HumeLink

Amendment Report

Rev 0

May 2024

FIGURE 3-8a: Overview of indicative controlled blasting locations

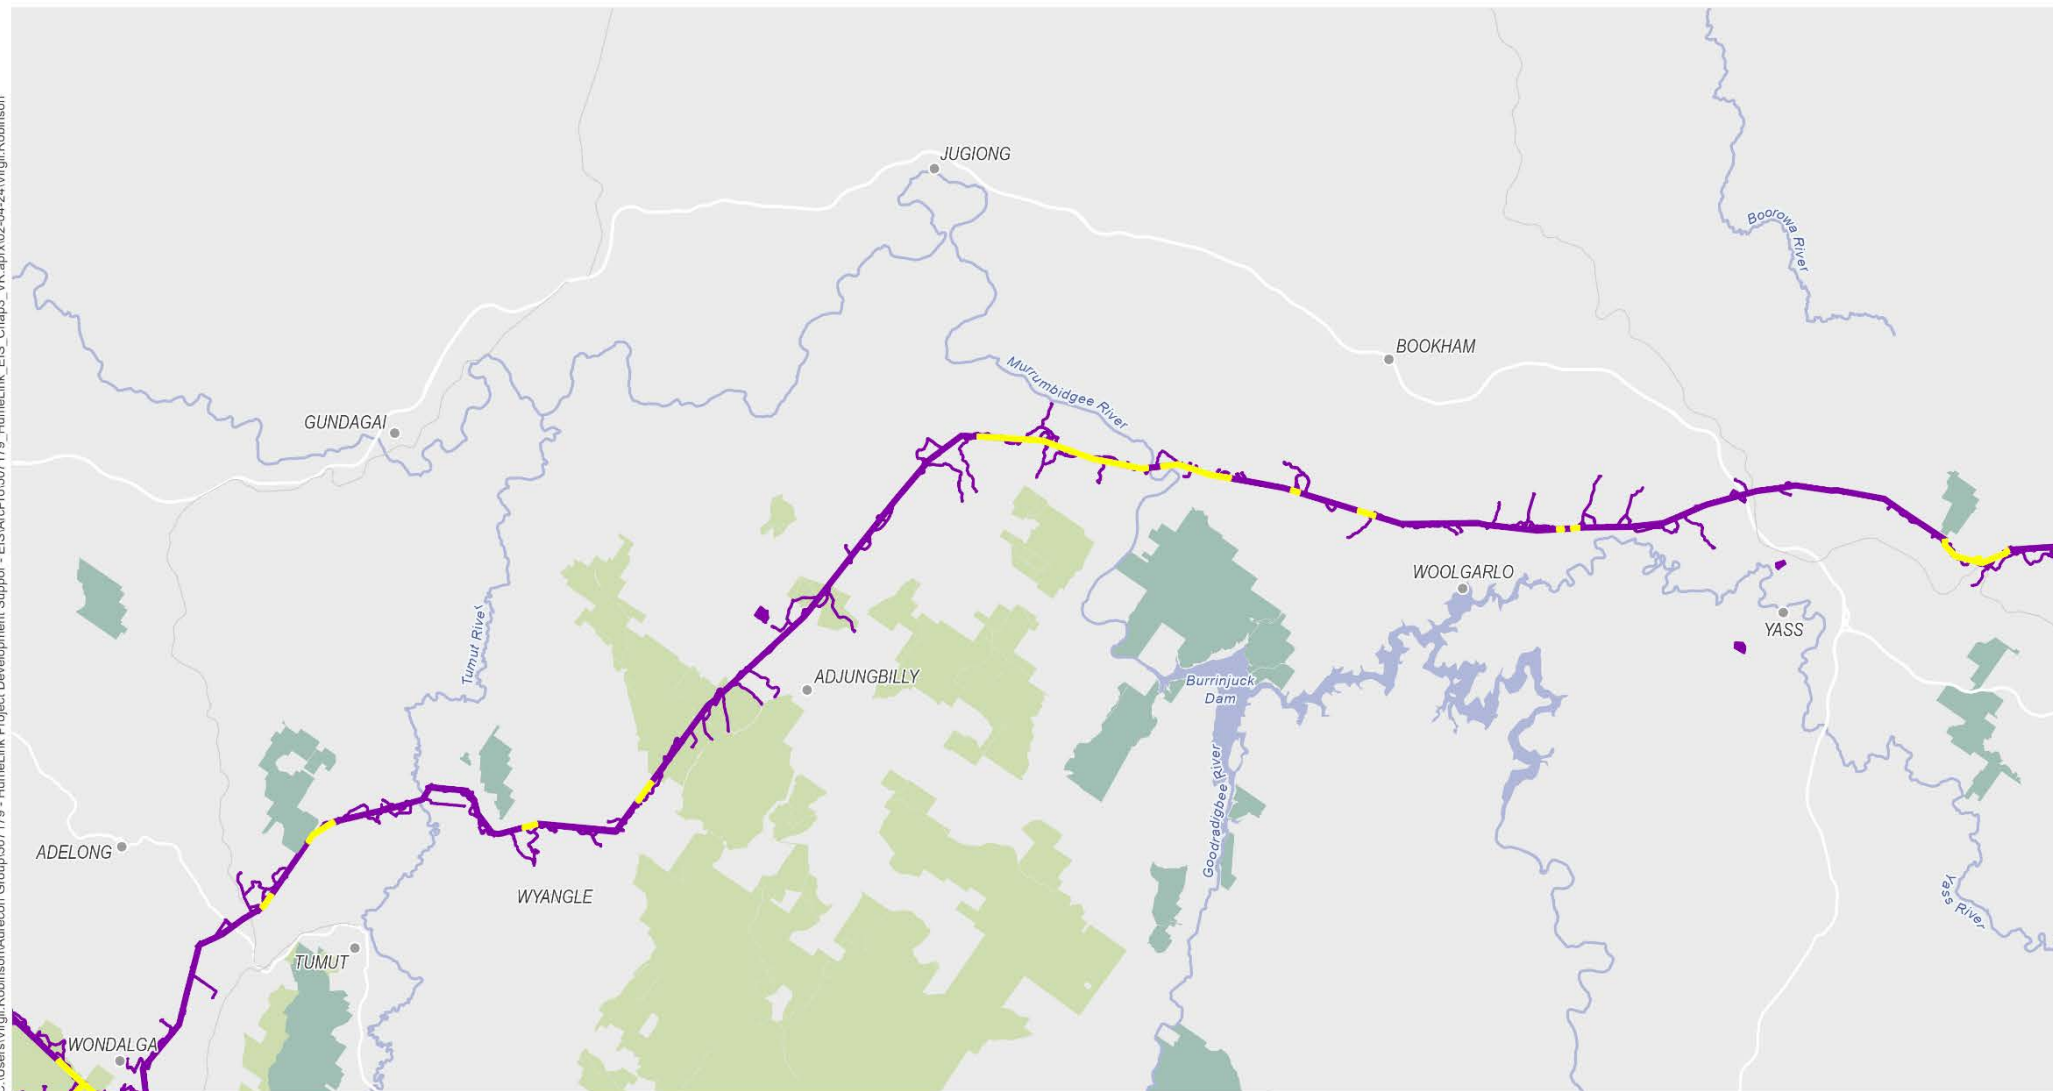
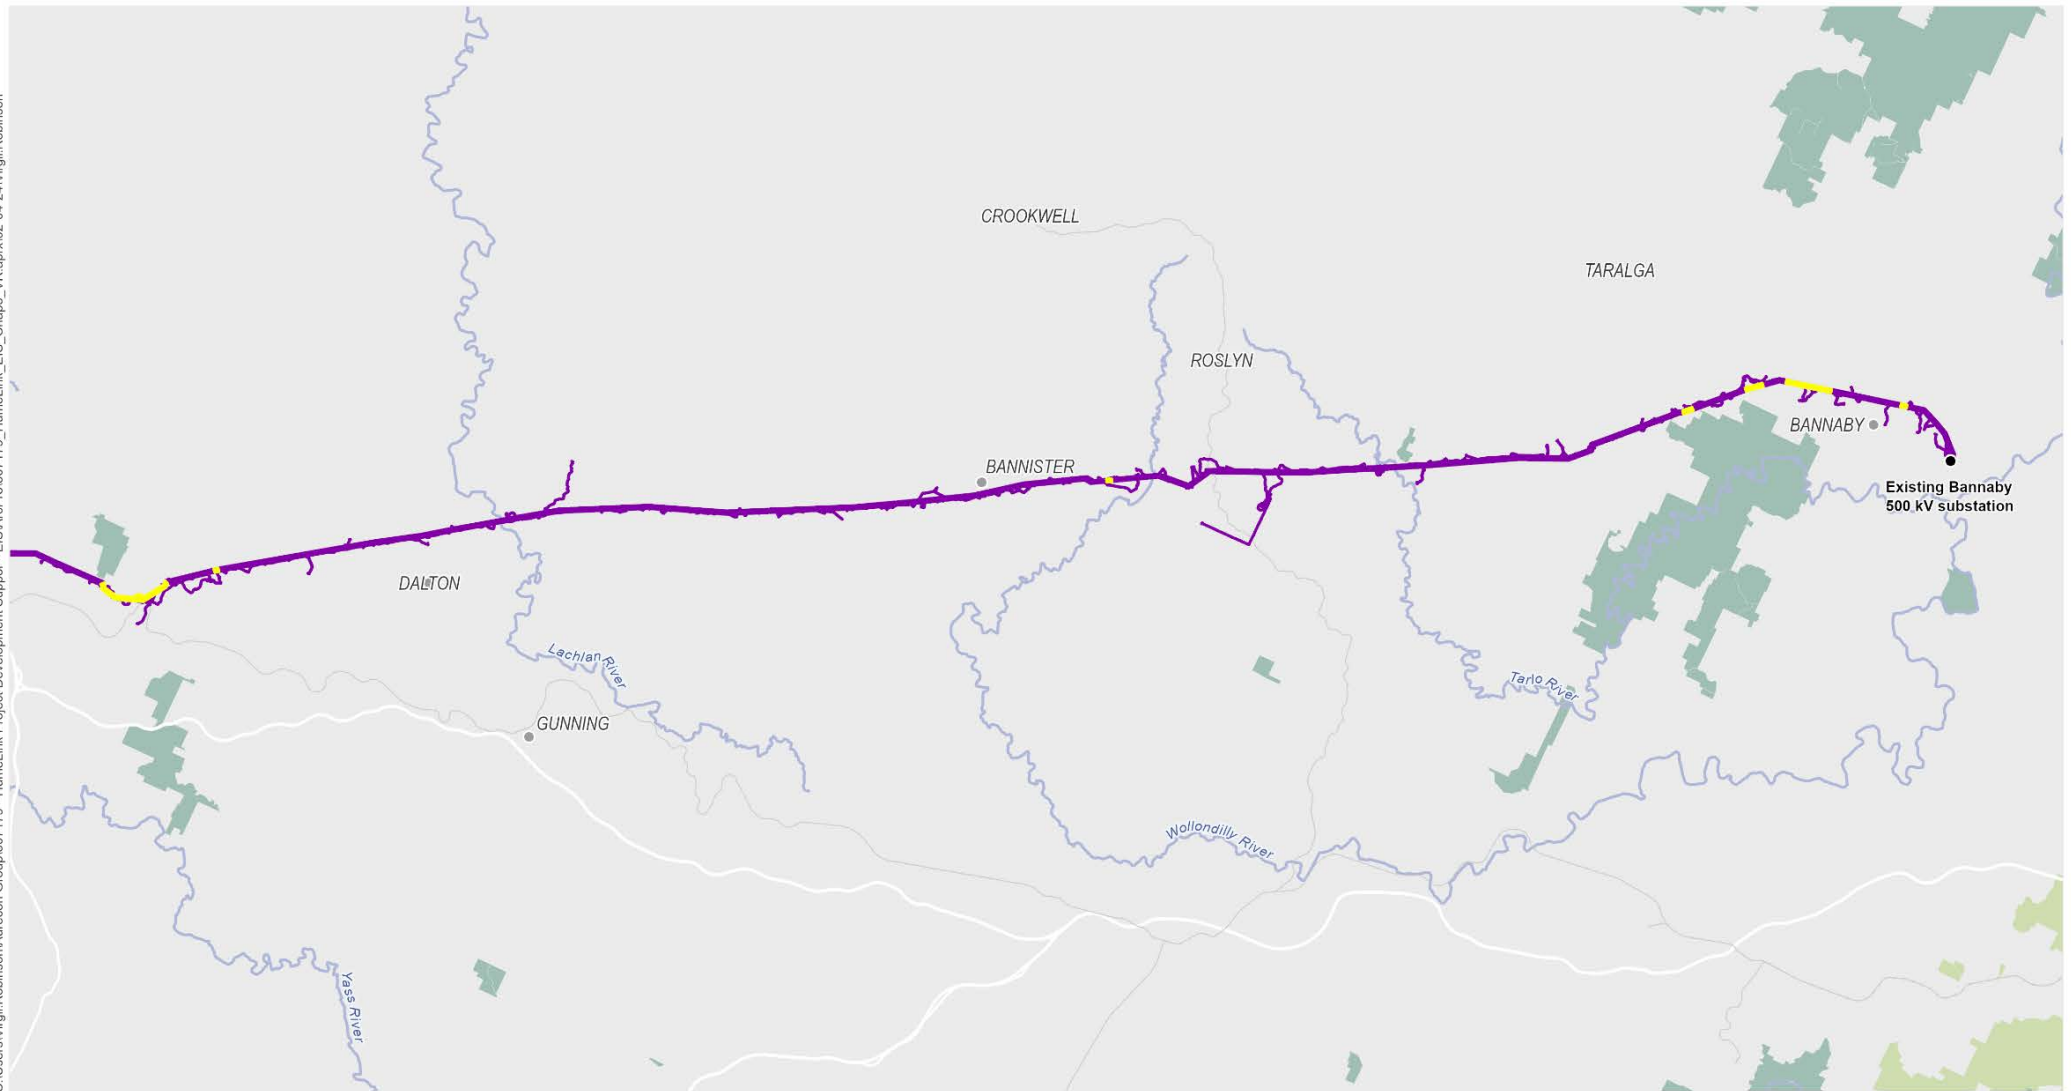
Preliminary geotechnical investigations and further consideration of terrain along the amended project alignment have identified several potential areas where controlled blasting may be required as an alternative to ripping or hammering of rock (refer to Figure 3-8). The extent of the potential areas identified has been developed for assessment purposes. Controlled blasting would not be required for the whole area and would be limited to specific locations within potential controlled blasting areas (refer to Figure 3-8), such as construction benches for transmission line structures and/or limited sections of access tracks. The benefit of controlled blasting would be minimising the earthwork duration and associated duration impacts on landowners at the specific locations within potential controlled blasting areas.
